**GARD initial response to
Gate 1 reports on
Strategic Resource Options**

7th August 2021

GARD Initial Response to Gate 1 Reports on Strategic Resource Options

Figure 2 - Recorded effluent outflows from Mogden STW 2013-2016

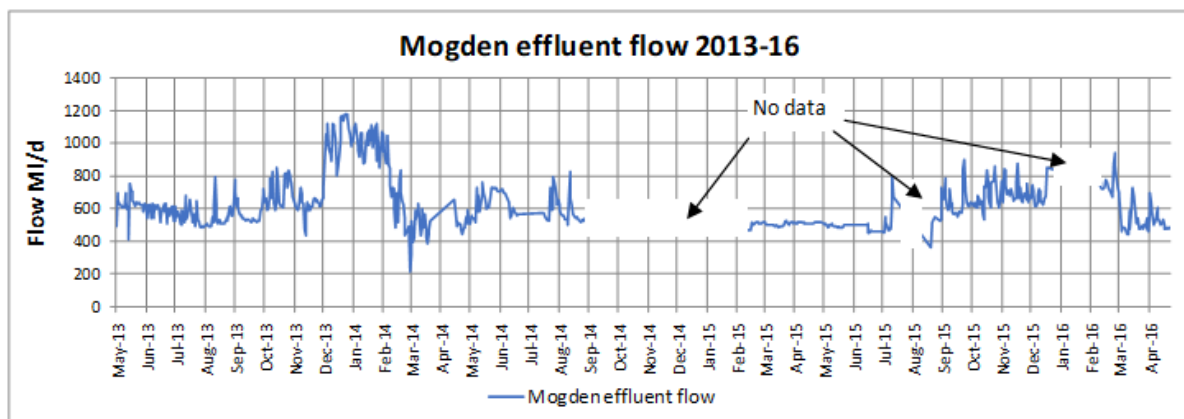
We agree that it is reasonable to consider a 300 MI/d scheme for Beckton reuse. However, we do not agree the limitation of the Mogden reuse options to a maximum of 200 MI/d. The recorded outflows from Mogden STW in 2016 are shown in Figure 3¹⁵:

The dry weather flow from Mogden is about 450 MI/d, so larger reuse options should be considered in Gate 2, probably up to 450 MI/d in the case of the Teddington DRA option.

Figure 3 - Impact of 350 MI/d regulation on flows below Vyrnwy dam

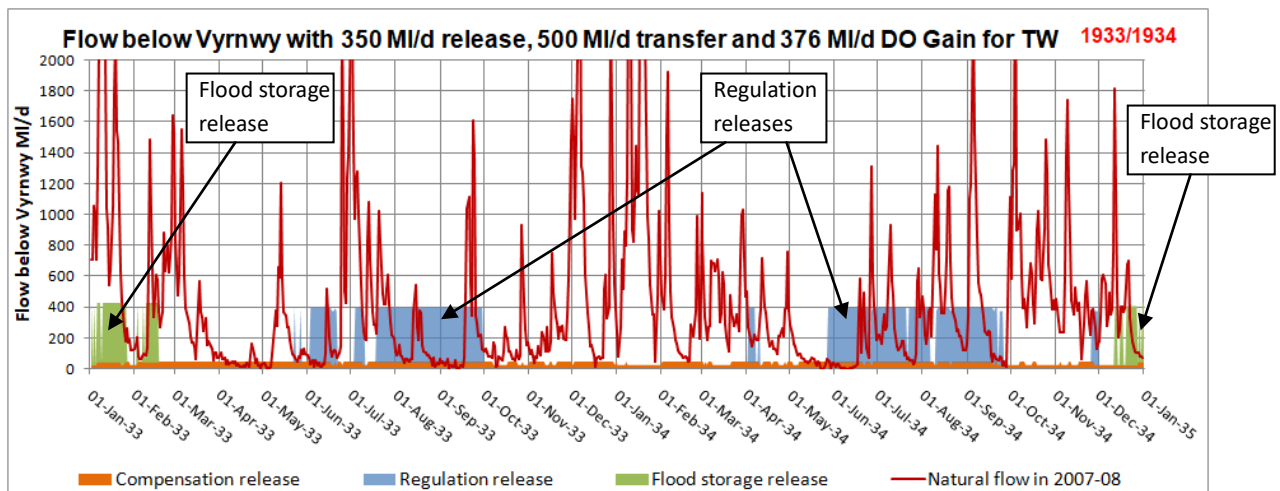
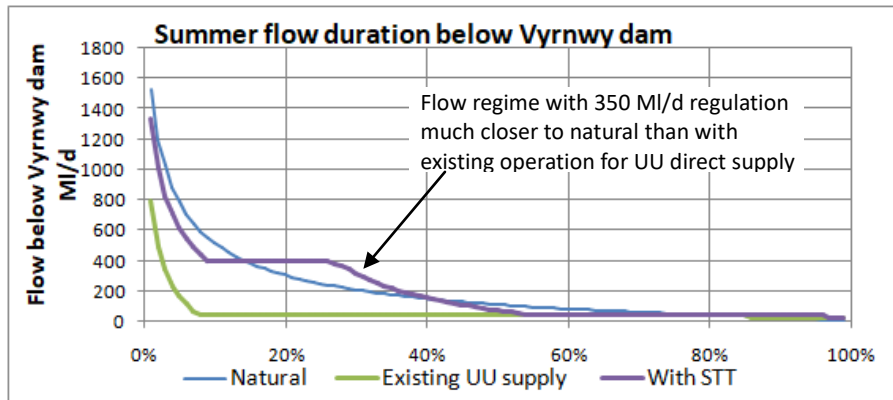
The impact of releasing 350 MI/d on flows below Vyrnwy dam is shown on Figure 2 below, which is taken from modelling of the 350 MI/d regulation scheme proposed by GARD for WRMP19 and described in Appendix C to this report. The upper plot shows flow duration curves for April to September, when most regulation takes place, and the lower plot compares flows in the drought of 1934 with the natural flows in 2007 and 2008, two naturally wet years:

The flow-duration plot shows that the April to September flow regime would be much closer to natural than at present when flows are continuously at the 25-45 MI/d compensation level. In geomorphological terms, this would be a marked improvement on the existing flow regime. The regulated summer flow of nearly 400 MI/d in a drought like 1934 would be unnaturally high as a continuous flow, but comparable to natural flows in wet summers like 2007 and 2008, albeit lacking the natural variation. At present, Vyrnwy dam flood storage releases of about 400 MI/d are made in most autumns and winters to lower the reservoir water level for flood retention – these releases are approved by NRW and deemed not to adversely affect the fisheries.

Figure 4 - Changes to flows due to regulation of up to 800 MI/d below Llyn Celyn dam

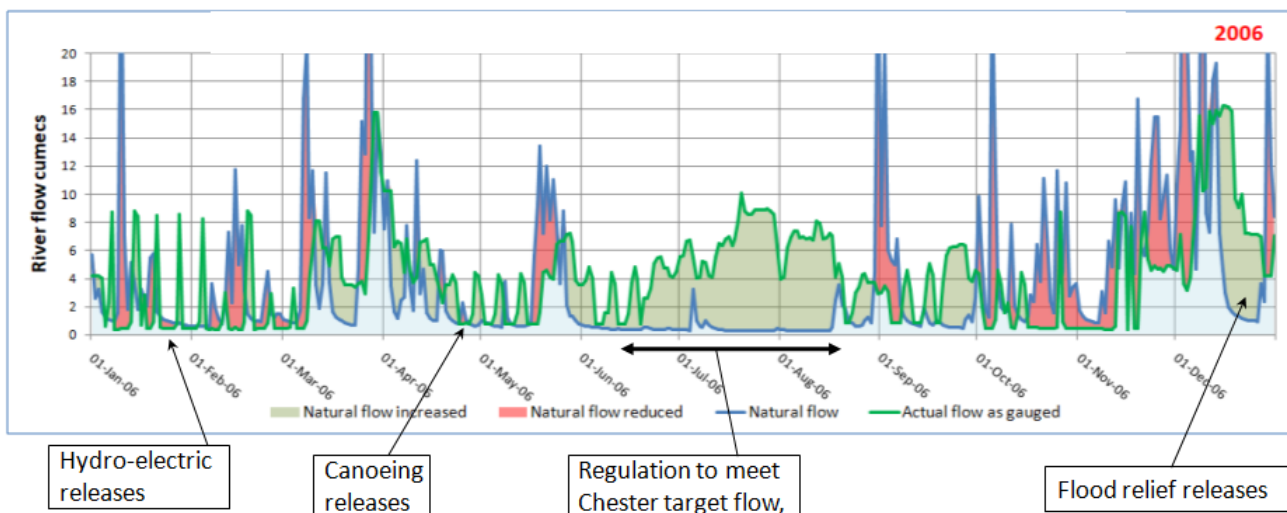
Evidence to justify larger releases into the Vyrnwy is provided by the example of regulation releases from Llyn Celyn into the Afon Tryweryn in the upper Dee catchment. Regulation releases of up to 700 MI/d (8 cumecs) have been made into the Afon Tryweryn continuously for many weeks per year since the construction of Llyn Celyn in the 1960s. This can be seen on Figure 3 below showing the impact of Llyn Celyn releases on Afon Tryweryn flows in 2006, a moderately dry year. On most days of regulation, the releases are subject to a within-day variation to give a peak release of about 800 MI/d (9.4 cumecs) for the benefit of recreational canoeing and rafting, giving highly unnatural within-day flow fluctuations.

This flow regime, including the large within-day fluctuations, is supported by NRW and it was approved by them in their Review of Consents for the Habitats Directive, under which the whole River Dee is protected.

Figure 5 - Comparison of juvenile salmon densities in the Dee catchment

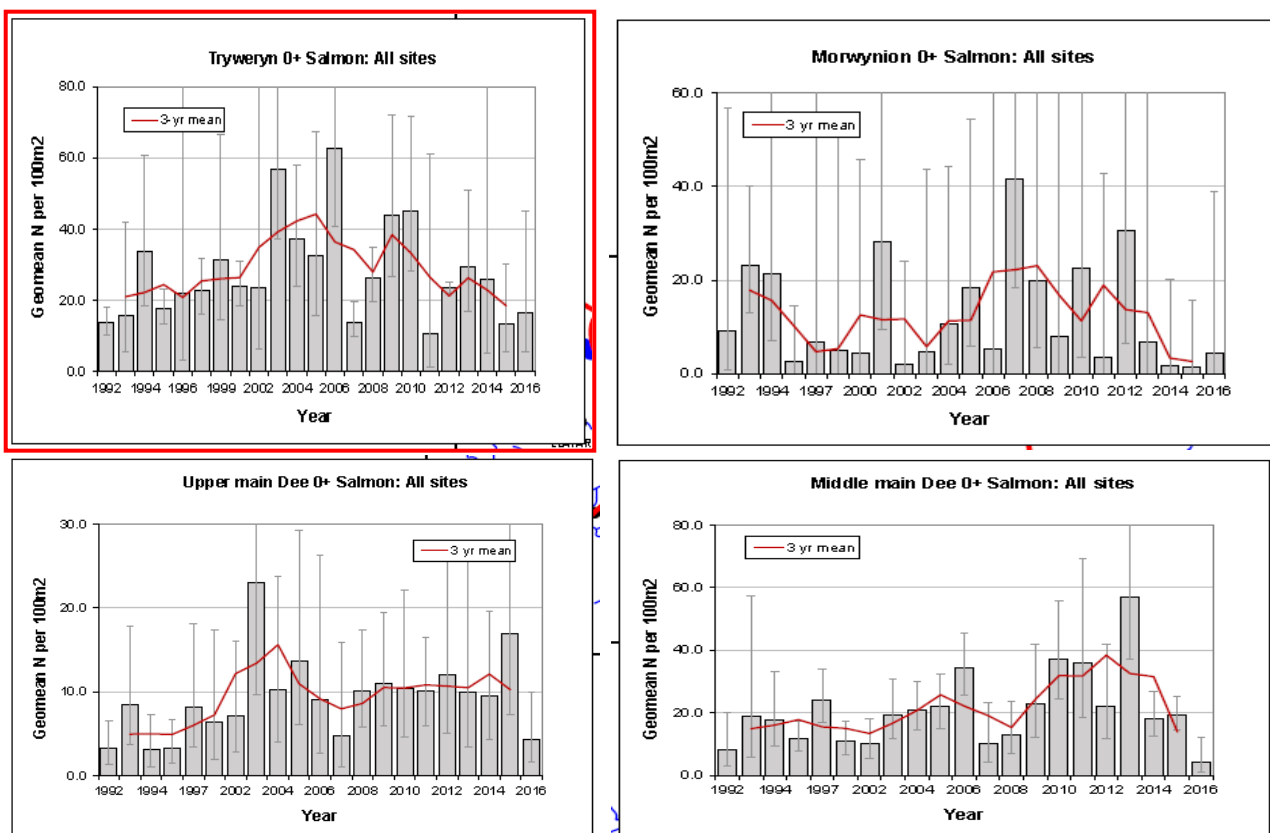
Part of the justification for accepting the extremely unnatural Afon Tryweryn flow regime is that it supports a healthy population of juvenile salmon, as shown in Figure 5¹⁶:

Figure 5 shows that the juvenile salmon densities in the Afon Tryweryn (highlighted) are similar to other parts of the Dee catchment, despite a flow regime that is a lot more unnatural than the flows would be below Llyn Vyrnwy with 350 MI/d regulation. The River Vyrnwy catchment area at the dam is 94 km², compared with 60 km² for Llyn Celyn. Therefore, it seems irrational that regulation releases of up to 800 MI/d are considered acceptable in the Afon Tryweryn, but only 75 MI/d can be released into the Vyrnwy, which has a 50% larger catchment area. It should also be noted that several substantial tributaries join the River Vyrnwy not far downstream of the dam, so the flow regime changes below the dam are soon dissipated by the incoming natural flows.

Figure A1 - WRMP19 and WRSE historic data periods in the context of global temperature changes since 1880

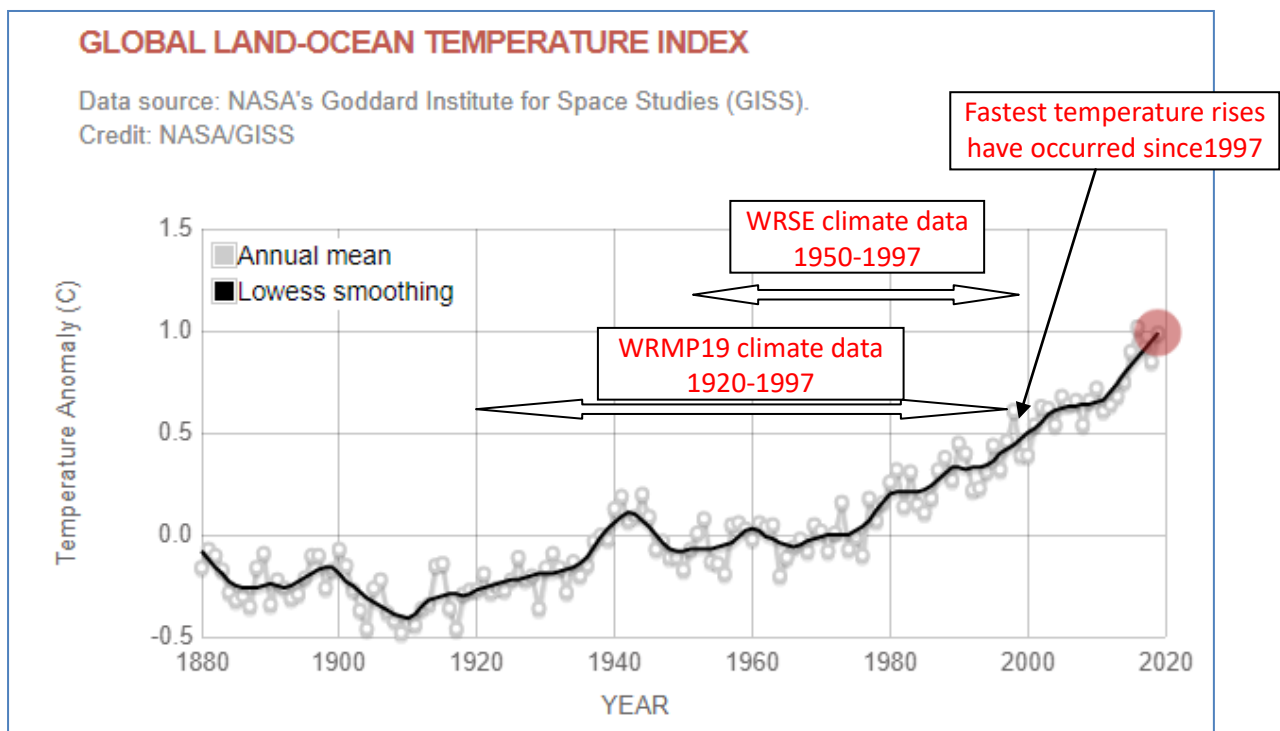
Figure A1 shows the periods of climate data used for the WRMP19 and WRSE stochastic data generation, in the context of global temperature changes since 1880²¹, highlighting the rapid changes since 1997:

Use of historic climate data only for 1950-1997 means the exclusion of:

- the past 20 years of most rapid climate change
- the droughts of 1921/22, 1933/34 and 1943/44, the three most severe droughts of the past 100 years for London's supplies

Therefore, the period 1950-1997 seems an unsatisfactory basis for generating the stochastic data, lacking both the period of extreme low flows pre-1950, with several long duration droughts, and the recent period of most rapid climate change.

Figure A2 - Changes in Lower Thames naturalised flow durations since 1883

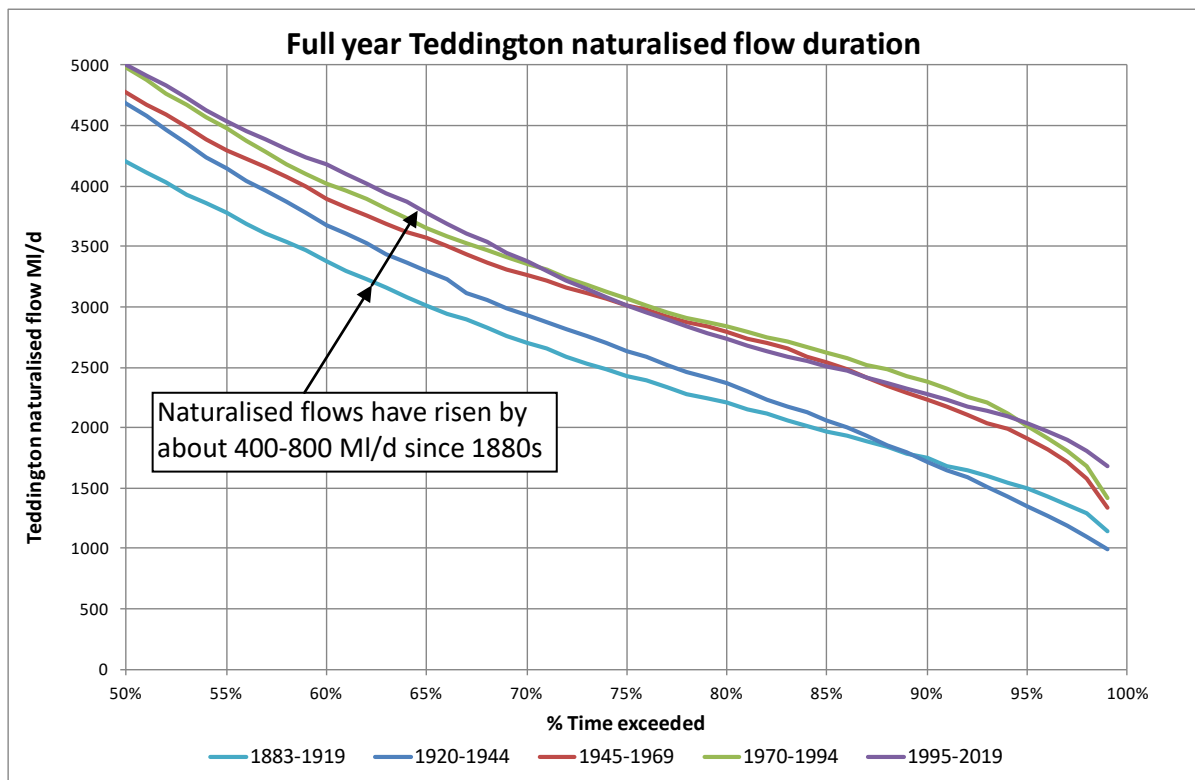
Figure A2 shows changes in the flow-duration characteristics of naturalised flows in the Thames at Teddington since 1885, ie the same period as Figure A1:

Over the past 140 years, the naturalised flow data show steady growth of about 400-800 MI/d in water available in the lower Thames for London’s reservoir-based supplies, although we recognise that there are some doubts over the reliability of the data from the early part of the record and the method of naturalisation does not take account of the abstractions and effluent returns above Windsor (relatively small as net values)²³.

Figure A3 - Differences in versions of hydrologically modelled flows on the lower River Test

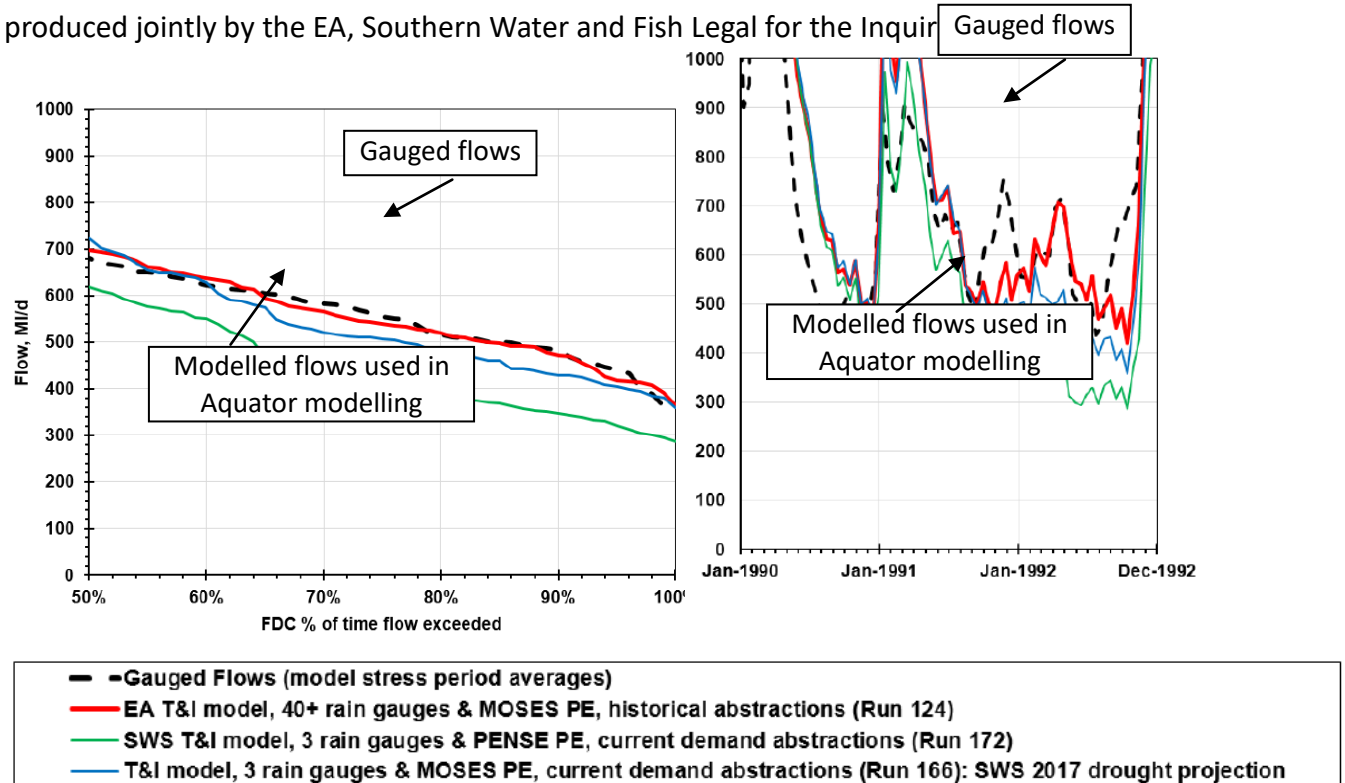
Southern Water’s Aquator modelling used the worst version of the hydrological modelling, the green line shown in Figure A3, for the reasons explained in the SOCG as follows²⁷:

Discrepancies of the magnitude shown in Figure A3 (ie. the differences between the green modelled flows and the black dashed gauged flows) would lead to major inaccuracies if they were to occur in flows used in WRSE’s regional system simulator. The difficulties described above will inevitably be experienced in the latest hydrological modelling – ie the absence of climate data covering historic droughts and the computational burden of applying the more accurate modelling techniques over thousands of years of stochastic climate data. These difficulties will be widespread over the south-east region, including the lower River Thames.

Figure 7-1 Operation of 500 MI/d STT with 350 MI/d Vyrnwy support & 15 MI/d Myth

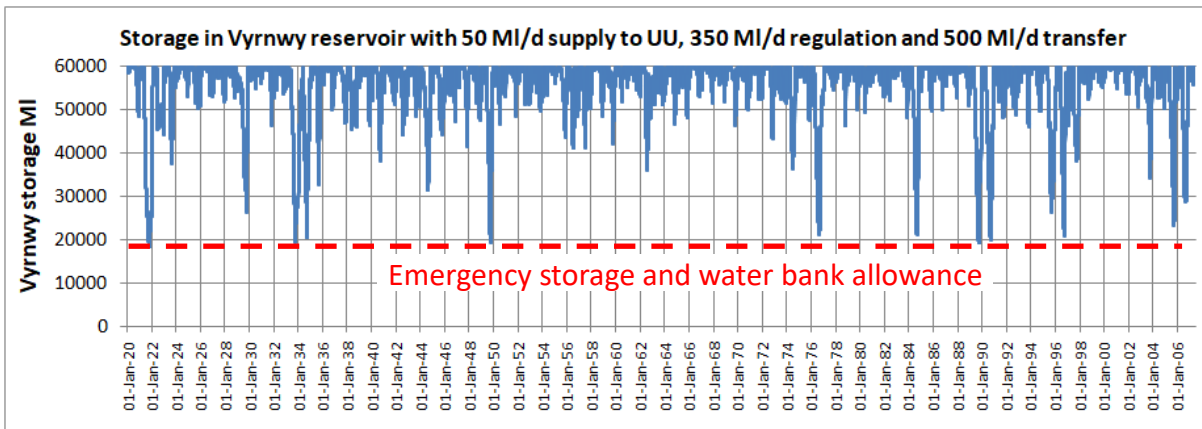
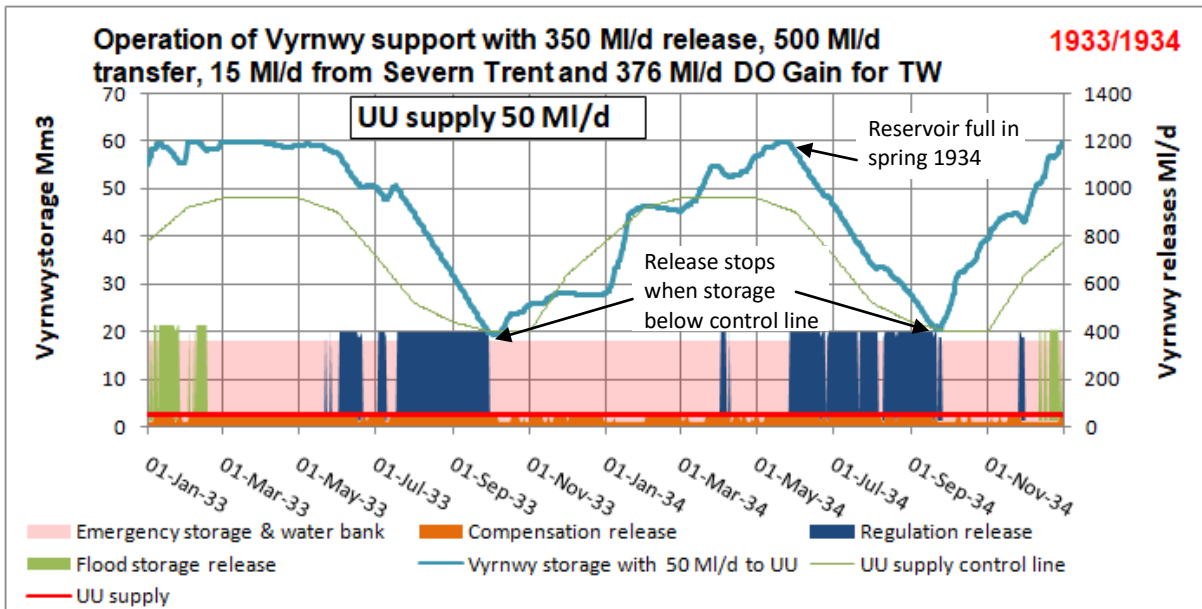
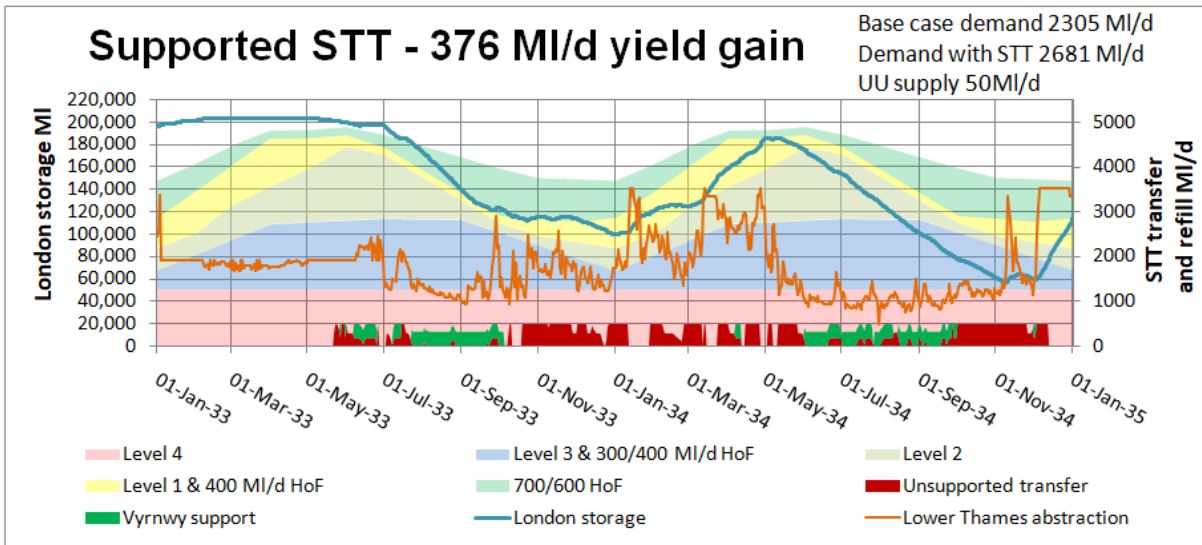
The modelled operation with United Utilities' guaranteed yield reduced to 50 MI/d and 350 MI/d regulation, giving a Thames Water yield of 376 MI/d, is shown in Figure 7-7:

The 50 MI/d yield still available to United Utilities is about 50 MI/d less than for the 180
